**From:** "Robert L Gill Jr" <rlgill@duke-energy.com>  
**To:** OWFN\_DO.owf4\_po(JMS3)  
**Date:** Fri, Nov 5, 1999 12:27 PM  
**Subject:** RV Leak-off Line Question

## Reactor Vessel Monitoring Pipe Questions

**BAW-2248 Renewal Applicant Action Items**

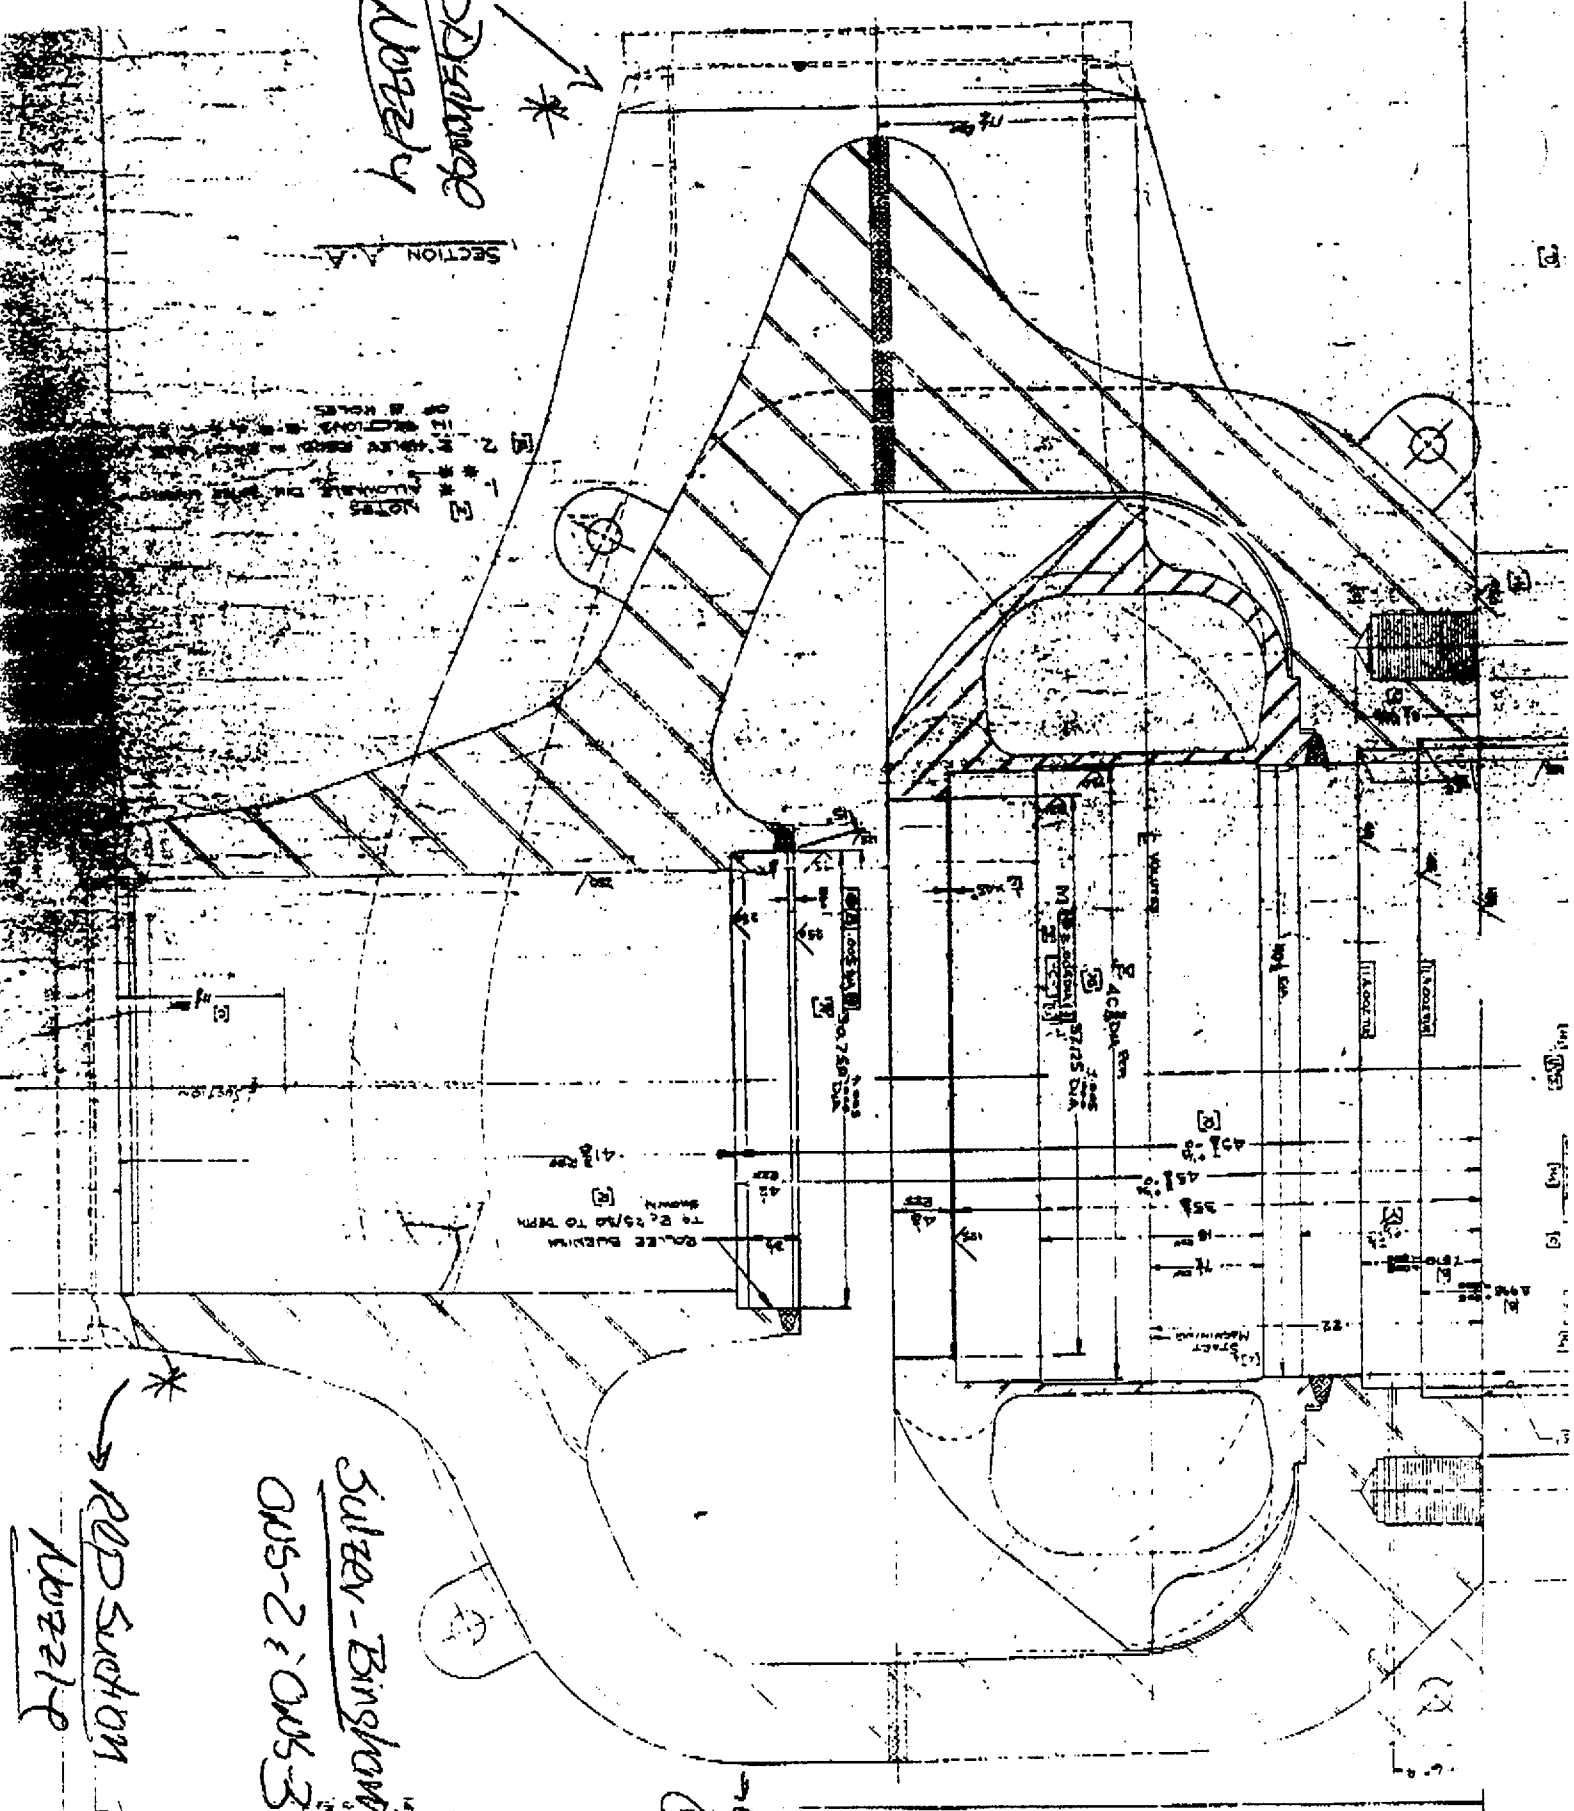
*ADD Drainage  
Wozzly*

*ADD Suction  
Wozzly*

*ADD  
Basin*
